# **FINAL-MY1 Monitoring Report**

## **Seniard Creek Mitigation Site**

**NCDMS Project No. 100017**

Subject: Draft MY1 Monitoring Report  
Seniard Creek Site, Henderson County  
French Broad River CU 06010105  
DMS Project ID No. 100017 / DEQ Contract #7189

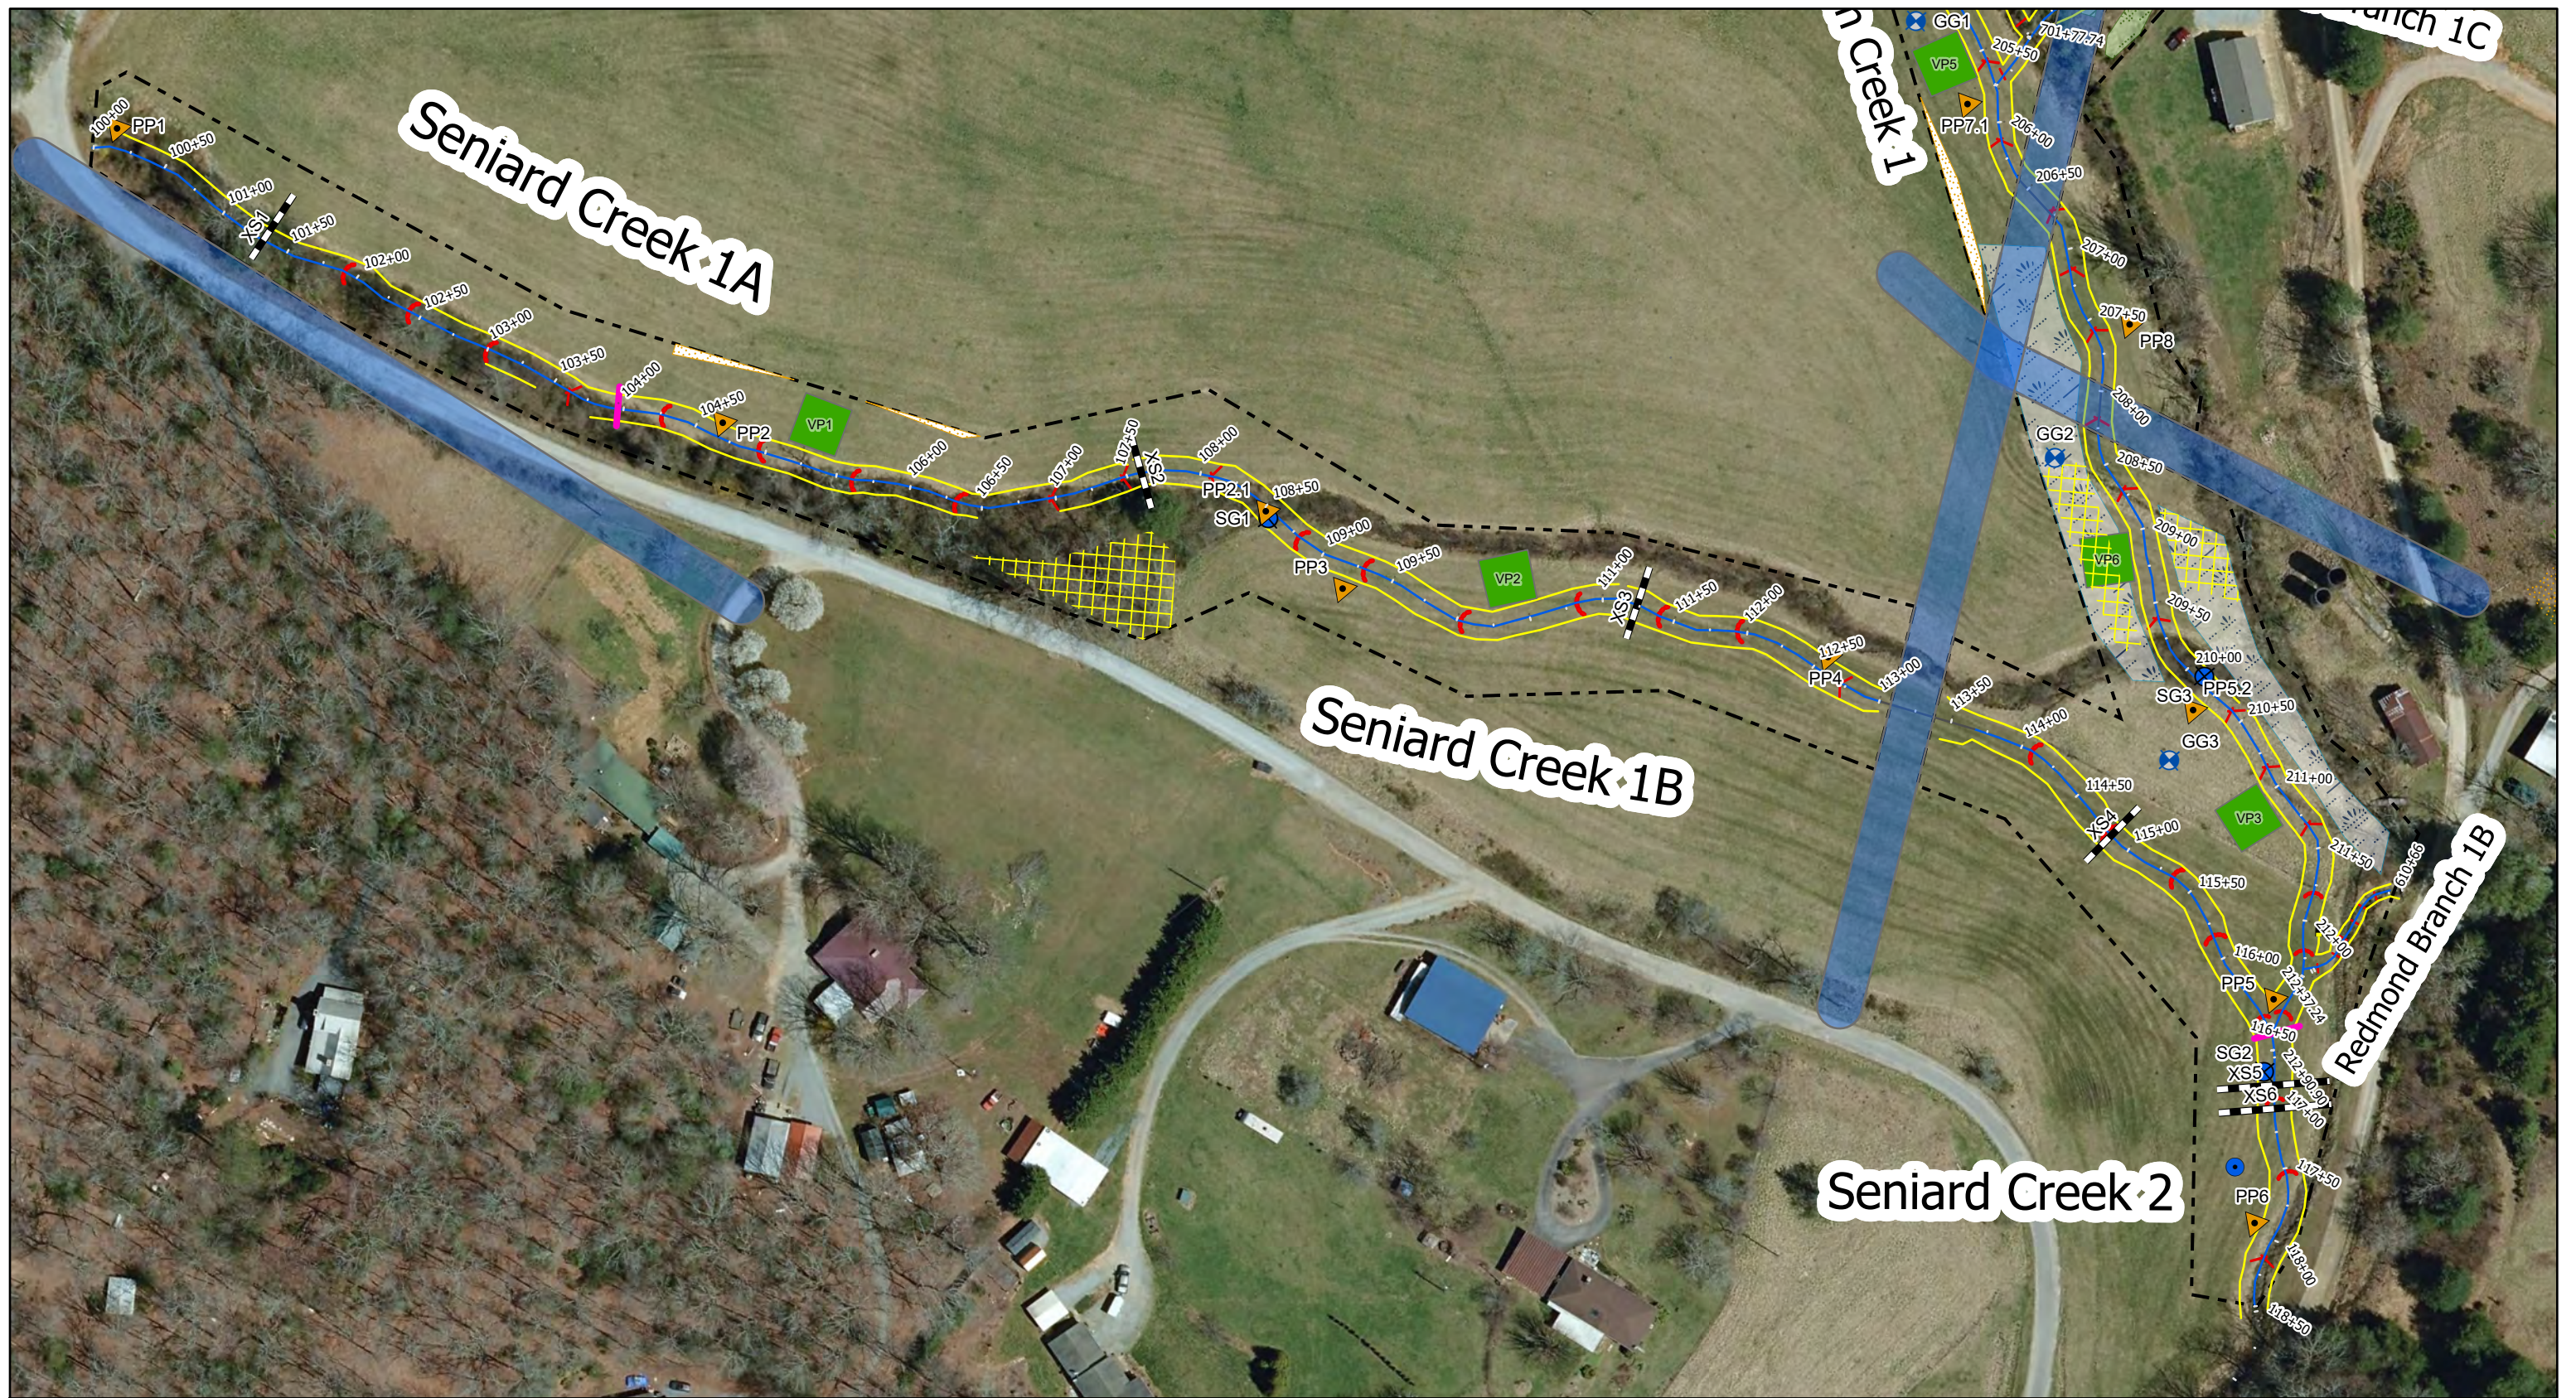
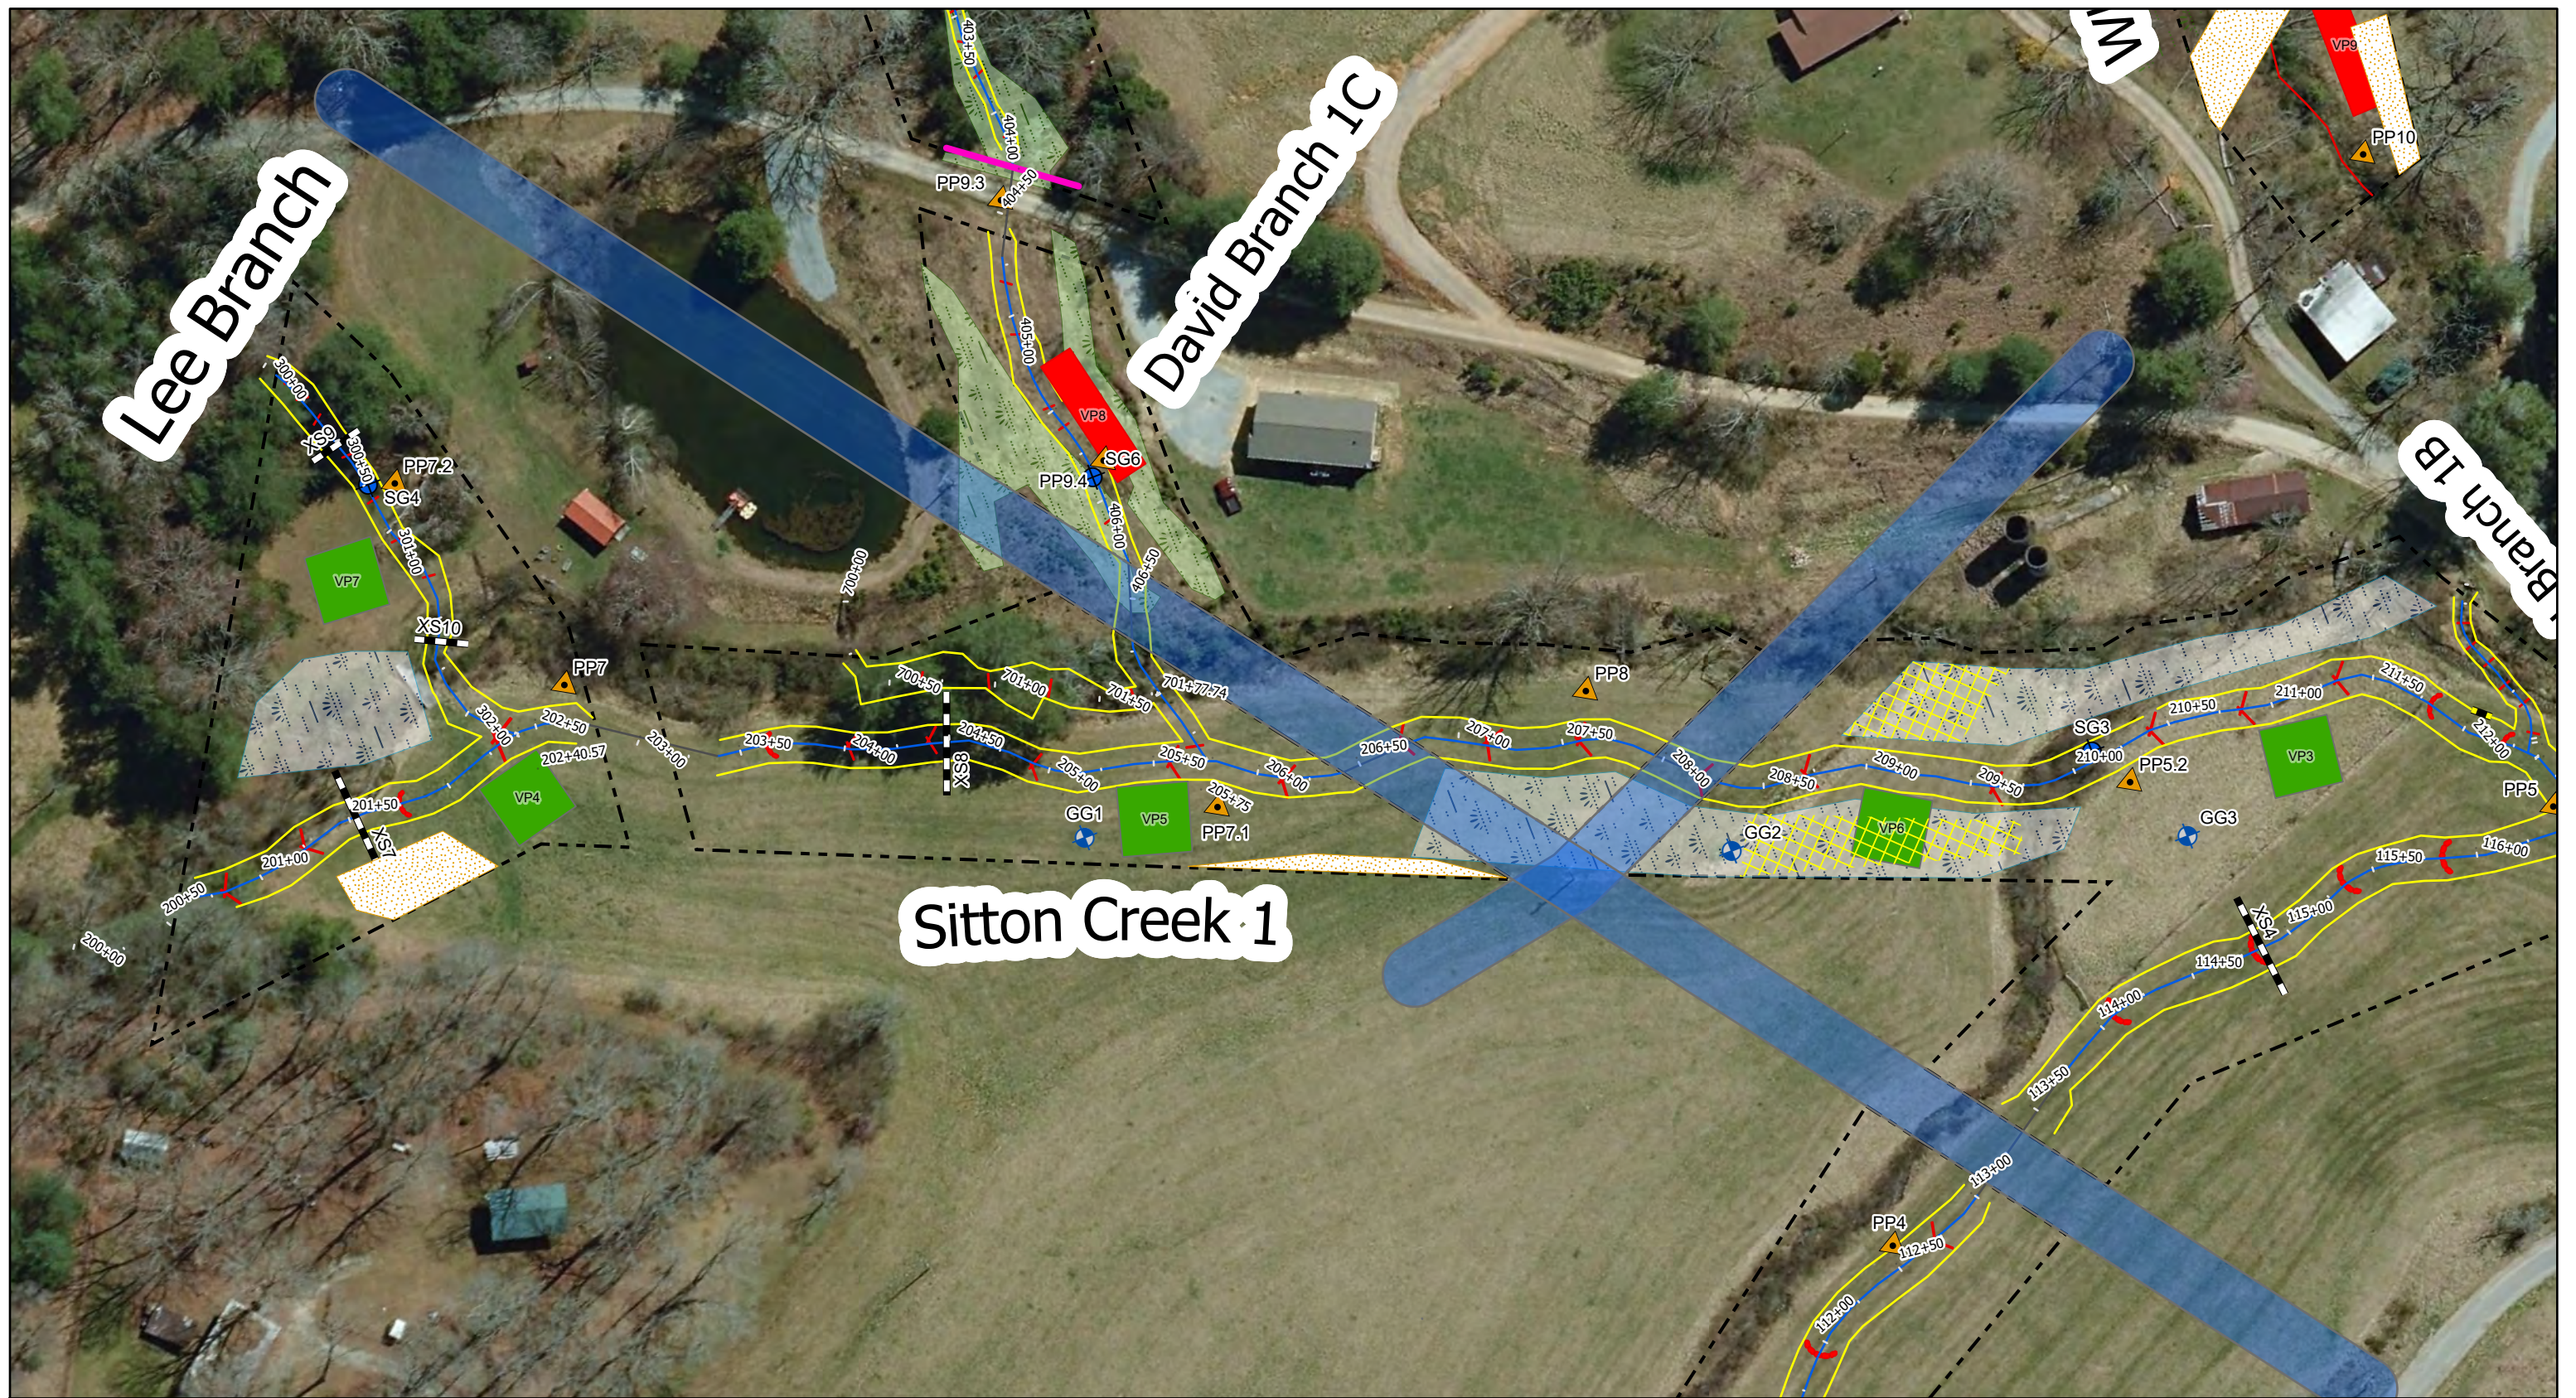
- During a recent site visit (Nov. 2021) by DMS there were a couple areas of low stem density and easement mowing/scalloping not showing on the CCPVs; please see PDF map attached to this email, acknowledge, and take these areas into consideration during the 2022 (MY2) assessment. There are also other boundary item comments and concerns noted that I would like your feedback on during the upcoming monitoring year. **We have reviewed the areas mentioned and will reassess them during MY2 monitoring. We will continue to address all boundary item comments and concerns.**

- Vegetation plots not meeting criteria (VPs 8 and 9) should be coded a different color (typically orange or red) than those meeting (green) on the CCPVs. **Coding added.**
